URBAN
GREENING
BAY AREA

DESIGN CHARRETTE SUMMARY – NOVEMBER 1, 2016

Prepared by: Lotus Water

Figure 3: Conceptual Layout for Bioretention Bulbout Variation One

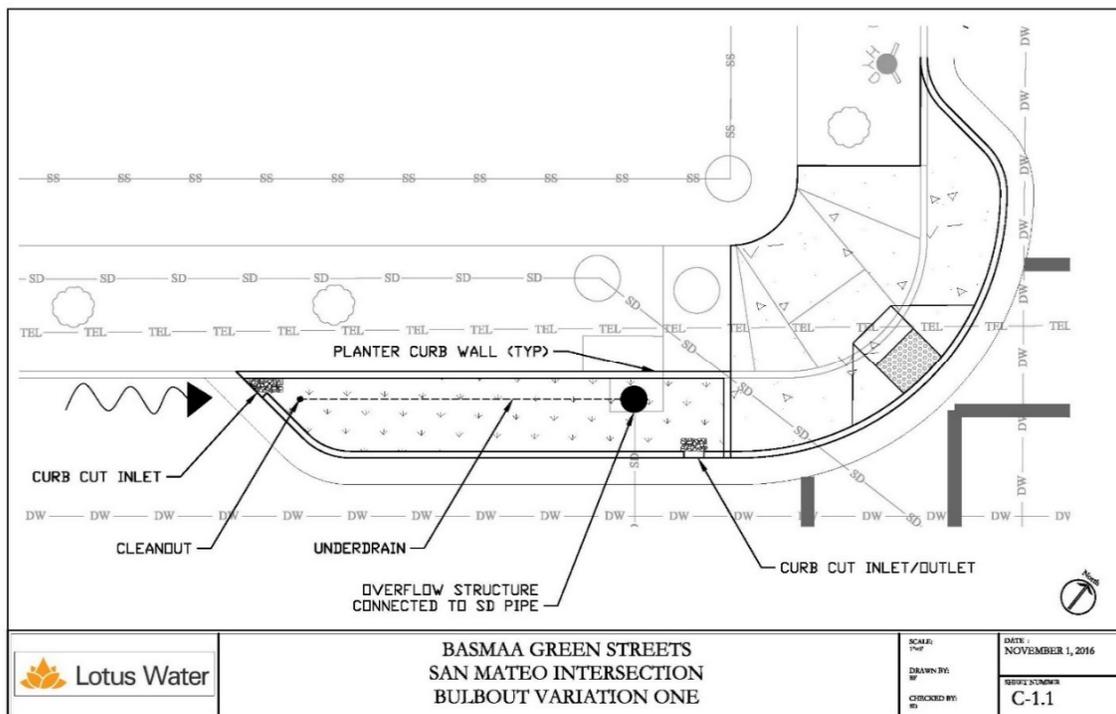
- Expand bioretention area into existing planter strip to eliminate need for retaining wall
- Expand bioretention area to perform better from a stormwater perspective
- Design is too “cookie cutter”
- Don’t block the inlet with plants—provide clear path for water to enter facility
- Create forebay for pre-treatment
- Consider incorporating street trees in design¹
- Consider the driver’s sight lines with plant selection—some plants listed exceed 5 feet in height
- Do not use filter fabric
- Create space for someone to sit and provide tree for shade
- Existing landscaping could serve as an upland zone and could potentially support trees

- Avoid retaining walls where feasible
- Use water barrier vs. deepened curb at roadway side
- Removing existing tree could provide opportunities to expand into planting strip and slope up to existing finish grade instead of installing concrete wall along this edge
- Consider economy of scale for bids – bundle projects to increase profitability for contractor and reduce unit costs
- Look for project synergies to reduce overall costs, i.e. split construction costs with ADA curb ramp improvement projects
- Use Tucson planting palette to remove need for permanent irrigation system

- Enhance forebay design for sediment/trash capture/maintenance purposes
- Enhance structural design of foundation/dowel curbs/cross bracing

- Can underground tree root area be excavated? It costs more but provides better sustainability.
- Clarify the design criteria – Water quality sizing or compulsory GI?
- Make GI essential to meeting pedestrian safety goals
- Sites with existing catch basins are more readily repeatable
- Promote green infrastructure as a solution to constructability of bulbouts
- Mitigate grade breaks and elevation issues with smart design

- a. Bioretention Bulbout Variation 1: Bioretention Area Extended into Planting Strip with 3:1 Maximum Slope from Sidewalk to Curb. Where existing trees and/or utilities do not prohibit grading within the planting strip, this option is preferred over the flat bioretention area with a retaining wall option, based on the retaining wall cost and concerns regarding the appearance of a drop-off next to the sidewalk. The following are some other suggested features that may be included in the final conceptual typical designs:

- i. Additional roadside curb cut inlets
 - ii. Two curb ramps at the corner if feasible
 - iii. 12-inch minimum wide bench adjacent to sidewalk and taller plants in upland zone to discourage pedestrian traffic within bioretention area

Figure 5: Conceptual Layout for Bioretention Bulbout Variation Two

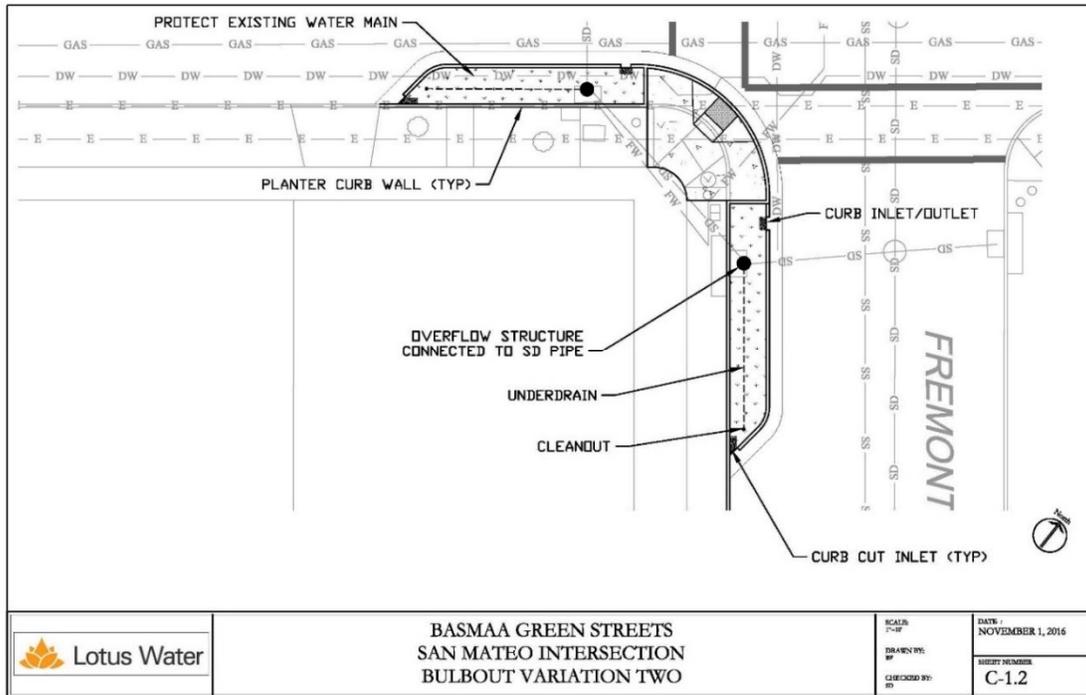
- Create a hydraulic connection between the two corner bulbouts using a subdrain or trench drain
- Expand and integrate bioretention area into adjacent planting areas if no existing trees (or trees need replacement)
- Add a concrete/rip-rap pretreatment forebay
- Keep trees on upland area and remove existing curb
- Use organic mulch to provide additional soil nourishment
- Provide low-growing grasses near the inlet and low-flow path
- Provide a meandering low-flow path to get water all the way into facility
- Consider offline condition
- Don't need both overflow and outflows in all situations
- Remove sidewalk-side curb walls where adjacent to existing trees to be saved
- Curb extension nose should be landscaped (too small to provide effective treatment)

- Keep one bidirectional ADA ramp at corners (San Mateo prefers having two ramps) if existing traffic light poles impede using two ramps (conflicts with path of travel). Moving traffic light is cost prohibitive.
- Complicated concrete forms cost more
- More storm drain structures equates to more money

- Study ADA code to see if raised portion of planter wall on sidewalk side could be flush since it's not immediately adjacent to sidewalk
- Consider extra costs of reducing street crowns, where necessary
- Seek opportunities for additional funding, e.g. Safe Routes to Schools Funds
- If bulbout project is combined with a Safe Routes to School project, consider extra costs and design coordination associated with new crosswalks, signage, and curb ramps

- Split bulbout costs with curb ramp improvement project
- Increase width of splash pad and mortar cobbles for energy dissipaters (improves ease of maintenance)
- Provide an enhanced forebay design to capture sediments and trash

- Provide bi-directional ADA curb ramps everywhere
- Use LIDAR/reroute data sets to screen potential bulbout sites (technical support needed)
- Create decision support system (parameters), i.e. “kit of parts” for intersection retrofit projects
- Produce one-page report with constraints to do field reviews

- iv. Enhanced splash pad/forebay design
- b. Bioretention Bulbout Variation 2: Bioretention Areas on Both Legs Hydraulically Connected and Extended into Planting Strips. This option maximizes the performance of the facility while reducing the number of connections to the storm drain main, thus improving its cost effectiveness. Careful consideration of site-specific intersection grading will be required to ensure that a proper hydraulic connection (via underdrains and surface flow) can be achieved and flooding concerns addressed without excessive maintenance requirements. The final conceptual typical designs may also include the following suggestions from the charrette, many of which are like those listed under Bulbout Variation 1:

- i. Transition grade down to bioretention area using slope in lieu of concrete retaining wall where feasible. Use stacked stone or precast retaining elements around existing trees and/or utility vaults to be kept in place.

- ii. Additional roadside curb cut inlets
 - iii. Two curb ramps at the corner if feasible
 - iv. Enhanced splash pad/forebay design
- c. Bioretention Bulbout Variation 3: Bioretention Area Incorporating Compacted Native Soil Perimeters. The use of compacted native soil benches around the edges of the bioretention planter would eliminate the need for costly retaining wall and water barrier features. It is noted that the Design Exercise II Group suggested a major configuration change to the conceptual bulbout design to provide a protected bike lane. The suggested change would create an island containing bioretention and reverse the locations of the bike and parking lanes, which would cause a ripple of road design changes for Duane Avenue, and other streets in which this typical design was applied. By locating the bioretention area away from the existing low point, this design would likely require significant intersection grading changes. Considering the goals of these typical concept bulbout design drawings, the project team recommends that the bioretention island idea be studied further under a different scope or be considered an individual landscape element without the stormwater management elements, and that the following suggestions be included in the revised Bulbout Variation 3 design:

Figure 7: Conceptual Layout of Bioretention Bulbout Variation Three

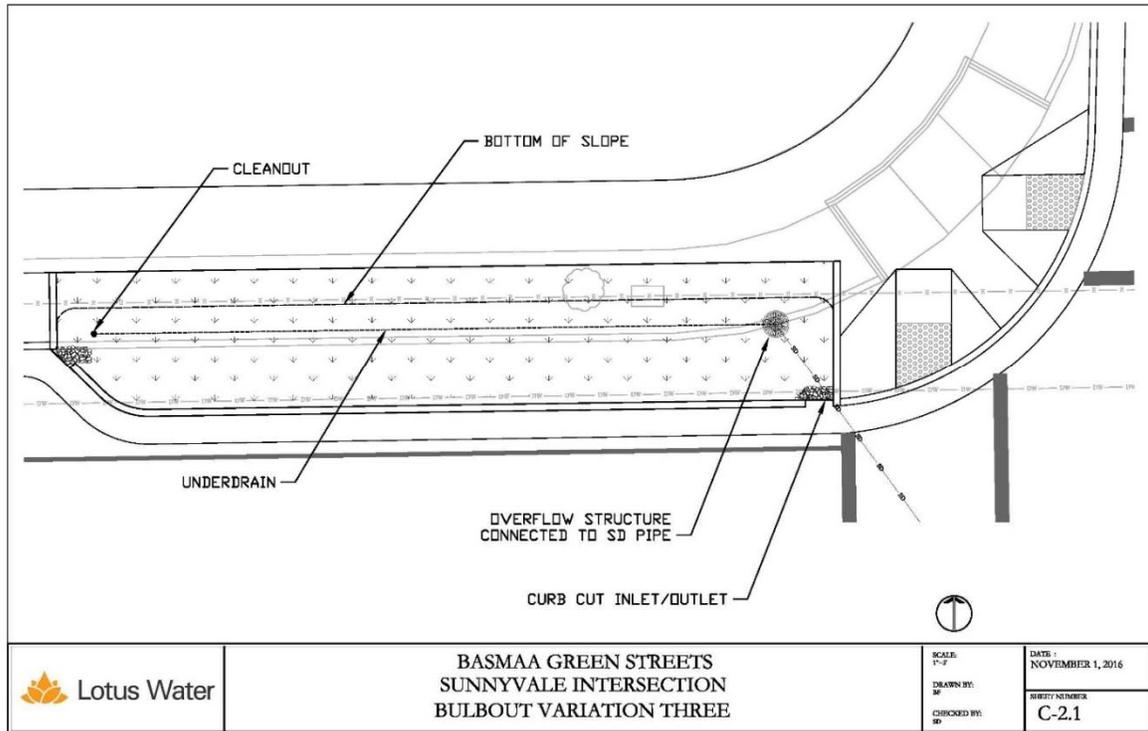
- Need to make sure water spreads evenly throughout facility
- Consider variability of planting for intersection character
- Taper depth of bioretention soil to minimize or eliminate deep curb
- The 2.5:1 slope is too steep for bioretention soil

- Add more curb cuts
- Don't need both overflow and outlet curb cut
- Be careful of creating tripping hazards with raised curbs on sidewalk side
- Too many layers in planting plan – simplify design
- Consider incorporating small trees within bioretention

- Using planter strip reduces transition height – reduced wall height results in reduced cost
- Modifying bioretention area into more of a square shape yields more bioretention area per unit perimeter which is more cost effective
- Include protection BMPs in project costs
- Consider using precast curb strips for retaining to lessen slope or just reduce cross-section with less biotreatment soil at slope edges.
- Develop utility compatible designs
- Leave utilities in place if feasible

- Utilize a “false” curb, where feasible
- Round corner with curb
- Address soil settlement during and after construction
- Design may not provide enough structural support
- Limb up trees within sight lines

- Pay attention to bulb radii to support existing/desired uses (bike lane, trucks/buses, street sweepers, etc.)
- Develop standard agreements, MOU’s and utility protection measures that meet the approval of all local agencies and utility providers

- i. Revise bulbout shape to be more square
 - ii. Protect utilities in place to avoid relocation costs
 - iii. Simplify plant layout using ground cover in low-flow channel areas and taller plants in upland zone; do not place plants at inlets

- iv. Add more curb cut inlets and ensure sidewalk can drain freely into bioretention planter
 - d. Bioretention Bulbout Variation 4: Combined Bioretention and Planting Area Adjacent to Raised Bike Lane at Midblock Crossing. Per the suggestion of charrette participants, the dedicated raised bike lane is shifted immediately adjacent to the sidewalk and the planting strip and bioretention areas are combined into a multifunctional green space which allows for a more flexible and creative landscape design. The wider footprint provides more space for sloped sides and varied topography and plant types. Additional suggestions that may be incorporated into the final typical conceptual design include:

Figure 9: Conceptual Layout of Bioretention Bulbout Variation Four

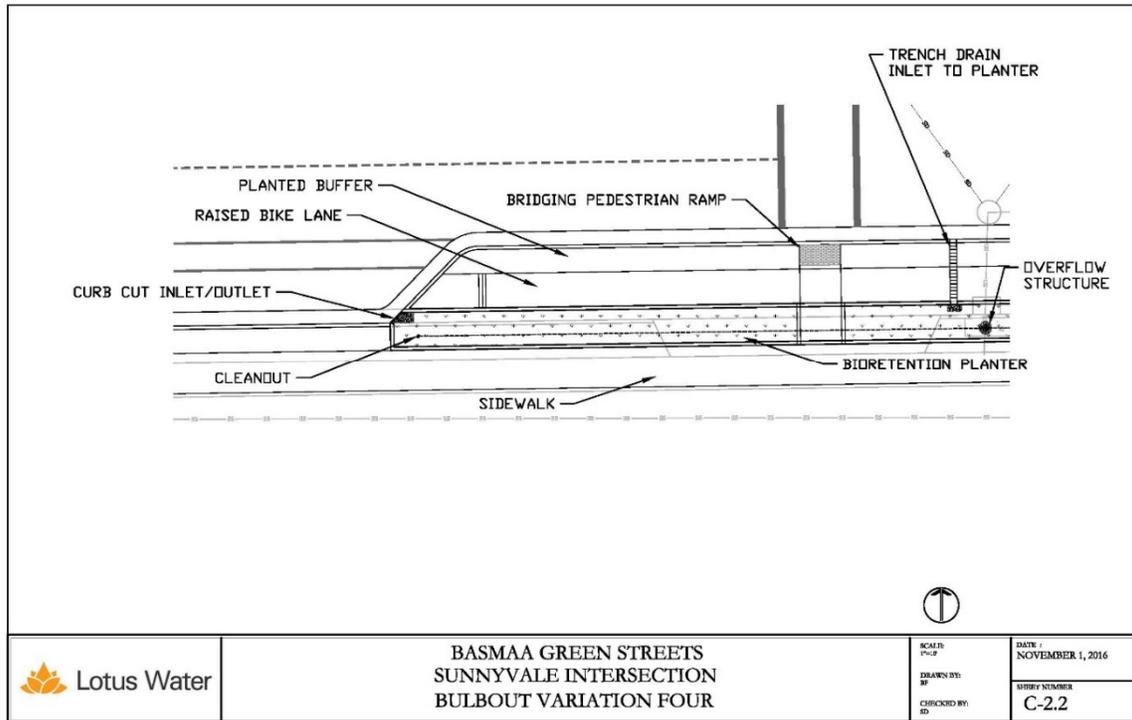
- Shift bike lane farther from cars
- Wide sidewalk to make it more inviting
- Revise to 9-foot wide bioretention area
- Make bioretention slope more gentle
- Create low flow channel feature that meanders through bioretention area
- Keep plants away from bike path to minimize hazards
- Move inlet to angle point of curb
- Provide concrete slab for splash pad for easy maintenance
- Planting may overhang edge of slab for aesthetics
- Hard to irrigate and maintain traditional planting strip portion
- Use prefabricated fiberglass reinforced bridge for pedestrian ramp crossing
- Combine planting areas
- Create bioretention zones

- Flip-flop bioretention and standard planting zones to create interest
- Include check dams and terracing
- Consider raised crosswalks
- The 30-inch maximum drop from sidewalk down to planter finish grade is too deep

- Remove one crosswalk across Duane Avenue
- Consider long term maintenance cost
- Use sleeves through solid curb ramp to connect bioretention areas
- Get community support for project, i.e. Adopt a Biofilter program
- Move bike lane south
- Cheaper to irrigate one larger strip vs. two long, skinny strips

- Remove trench drain
- Provide check dams
- Include trash capture/curb cut pad at inlet

- Consider using/developing precast bulbout components
- Consider situations in which road diet strategies conflict with bulbout designs

- i. Remove one crosswalk across Duane Avenue
 - ii. Use solid curb ramp crossing with culverts/pipes to hydraulically connect bioretention areas in lieu of more expensive boardwalk-style pedestrian crossings.

- iii. Add more curb cut inlets
 - iv. Provide raised pavement markers or something similar to safely delineate the bike lane from the sidewalk
 - v. Ensure pedestrian/bike crossings are safe and meet all applicable code

- vi. Create meandering low-flow channel
 - vii. Consider sight lines at pedestrian crossings
 - viii. Create forebay to capture trash and sediment at first inlets

Bulbout Variation One

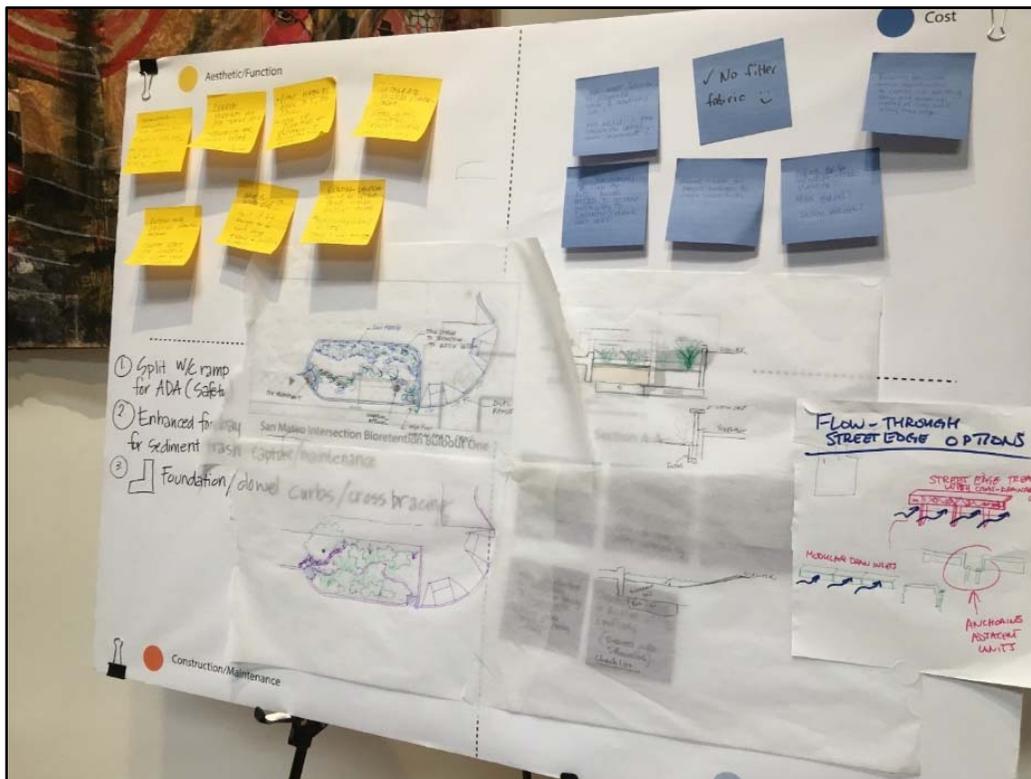
- Functional Elements:
 - Curb and gutter
 - DMA contribution varies
 - Expand into existing planter strip
 - Too cookie cutter
 - Don't block the inlet
 - Forebay consideration
- Create forebay for pre-treatment
- Opportunity for street trees
- Plant materials grow to 5', too tall
- Open planting at entrance to bioretention area
- Integrate existing planting area
- Avoid walls

- Extend into existing planting area
- Create space for someone to sit, tree for shade
- What is watershed? Is it big enough to be worth doing?
- Expand to perform better
- Existing landscaping could be upland zone, maybe support trees
- Add functional curb and gutter
- There is non-functioning curb/existing

- Use water barrier vs. deepened curb at roadway side? Not needed, is there concern for lateral water movement?
- No filter fabric
- Removing tree could provide opportunities to expand into planting strip and slope up instead of conc. Wall along this edge
- Consider economy of scale for bids – bundle projects to increase profitability for contractor/reduce unit costs
- General – look for project synergies to reduce overall costs
- Removing tree could provide opportunities to expand into planting strip and slope up instead of conc. Wall along this edge.
- Explore irrigation – tree planting
- More gravel?
- Tucson palette?

- Standard Detail – to resolve conflicts (sleeves under sidewalks)
- Can underground tree root area be excavated? More money but better sustainability
- Design criteria – WQ sizing or Compulsory GI
- Make GI essential to meeting pedestrian safety
- Sites w/ catch basins more readily repeatable
- Green infrastructure as a solution to constructability of bulb-outs
- Mitigate grade breaks and elevation issues

Bulbout Variation Four

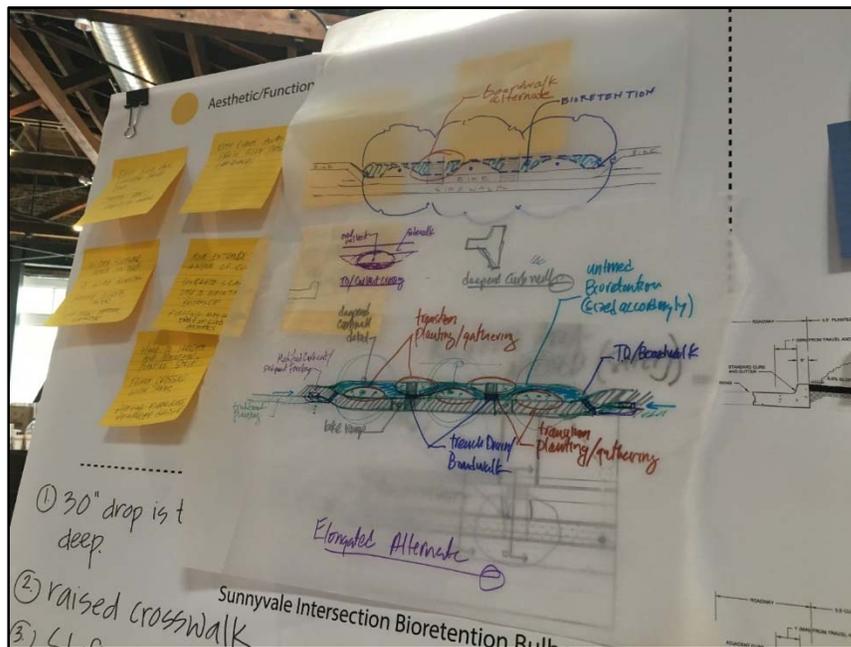
- Shift bike lane farther from cars
- Create stop/respice area
- Wider sidewalk make inviting
- 9' wide bioretention
- Gentle slope, taper
- Low flow feature/meander
- Keep plants away from bike path (hazard)
- Move entrance to angle of curb
- Concrete slab easy to maintain at entrance
- Planting may overhang edge of slab for aesthetics
- Hard to irrigate and maintain planting strip
- Frame crosswalk with trees
- Prefab fiberglass reinforced bridge
- Combine planting areas
- Create congregation zone

- Create bioretention zones
- Flip-flop zones to create interest
- Check dam, terracing
- Put bioretention closer to street
- Don't separate – join the 2 planting strips

- Remove one crosswalk
- Consider long term maintenance cost
- Instead of bridging curb ramp, use sleeves through to connect bioretention areas
- Trash capture/curb cut pad
- Community buy in – adopt a biofilter
- Combine bioretention planter C street/ move bike lane south
- Cheaper to irrigate one larger strip vs. two long, skinny strips
